Town of Kittery Planning Board Meeting July 12, 2018

Miller Road – Major Subdivision Preliminary Plan Review

RE: Town of Kittery, Planning Board Services
Preliminary Subdivision Plan Review #2-Miller Road Subdivision
CMA #591.119

PRELIMINARY SUBDIVISION PLAN
MILLER ROAD SUBDIVISION
MILLER ROAD, KITTERY, MAINE

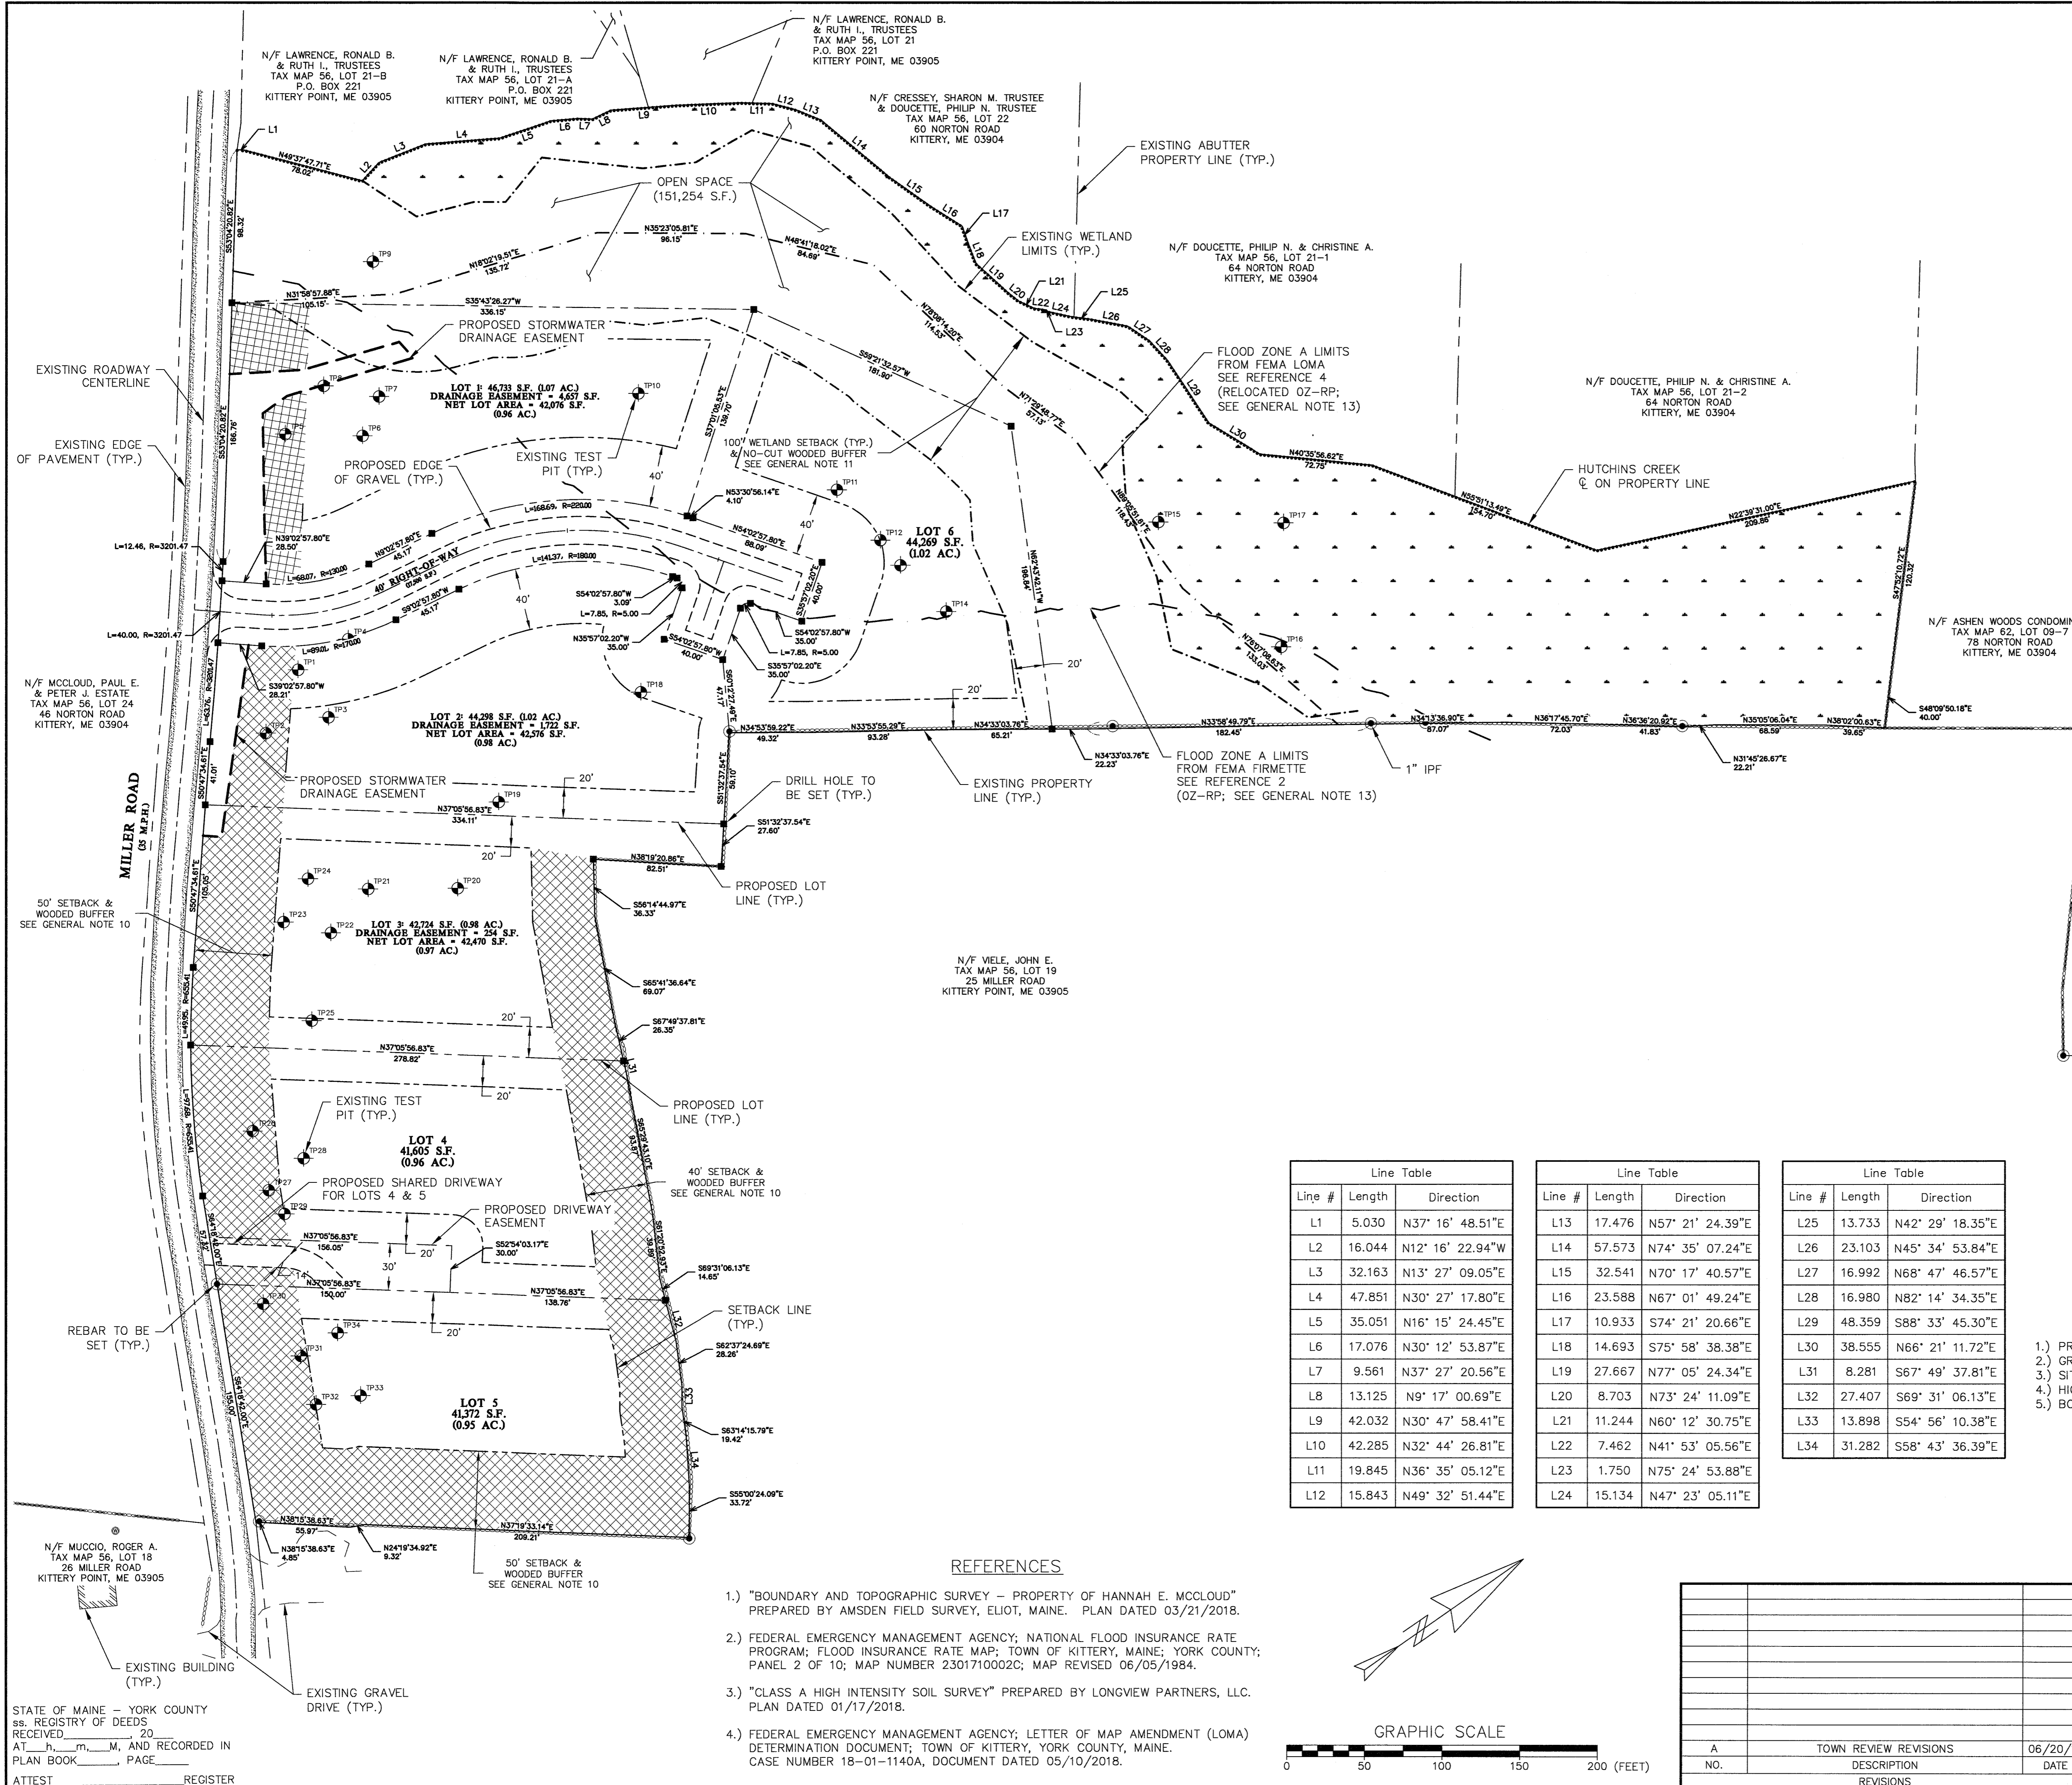
5. Calculations for Net Residential Acreage. Per Title 16.7.8 *Net Residential Acreage* has been calculated and is shown as note 6 on Sheet 1 of the plans.

- a. Was the new stormwater drainage easement shown on Lot 1 included in the calculations? Update: The land area included in rights of way and easements for the net residential area calculations has remained the same for all plans submitted since April. Is this correct? If not, the calculations should be updated to reflect the road easement and the stormwater drainage easements shown on the plans.

ROAD CROSS SECTION - TYPICAL (SCALE: NTS)
GRAVEL FILL TO BE COMPACTED TO 95% MODIFIED PROCTOR

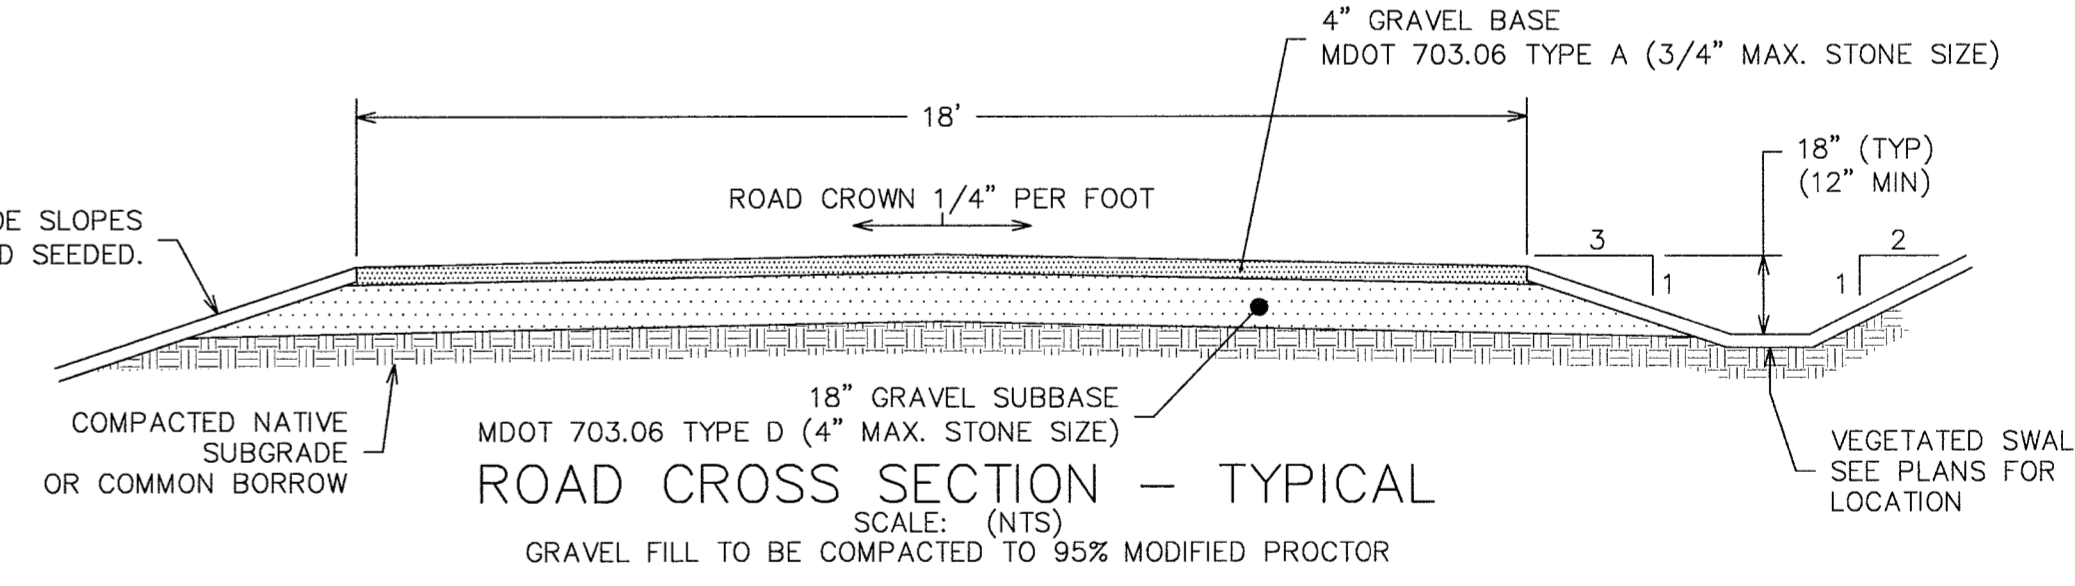
16.8.4.3.I. This street would be classified as a Class I private street. In accordance with Table 1, the applicant should label the right-of-way width on the Road Cross Section – Typical detail on Sheet 3.
